**SUNDRY NOTICES AND REPORTS ON WELLS**

OXY USA WTP Limited Partnership

OXY USA WTP LP  
Myers Langlie Mattix Unit #23  
API No. 30-025-25986

**SUNDRY NOTICE SPECIAL STIPULATIONS**

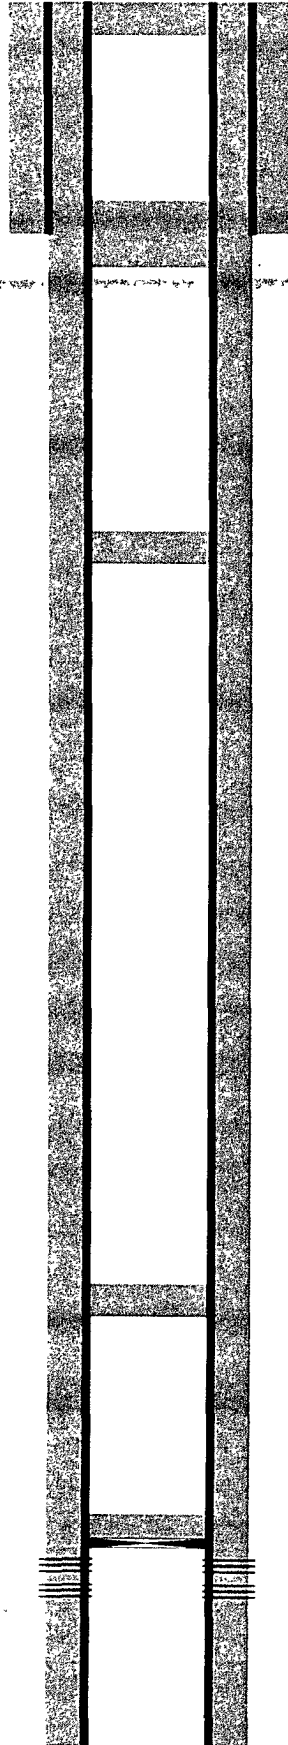
1. Approval is granted to plug this well with the following modifications to the proposed plugging procedure.
2. The plug proposed for 2850' should be moved to 2532' with perfs and a squeeze of 40 sacks of cement, leaving at least 25 sacks inside of the casing.
3. The plug proposed for 1185' should be moved to 1234' with perfs and a squeeze of 35 sacks of cement, leaving at least 25 sacks inside of the casing.
4. A perf and squeeze with 35 sacks of cement should be added to plug proposed for 558', leaving at least 25 sacks of cement inside of the casing.
5. Add a perf and squeeze @ 60' with 25 sacks of cement for the surface plug.

**\*\*\*All plugs below the surface plug must be at least 100' and 25 sacks of cement plus an additional 10% for each 1000 feet of depth.**

**Plugging procedures must conform to 43 CFR 3162.6.d and Onshore Order No. 2.III.G or NMOCD orders if they are more stringent.**
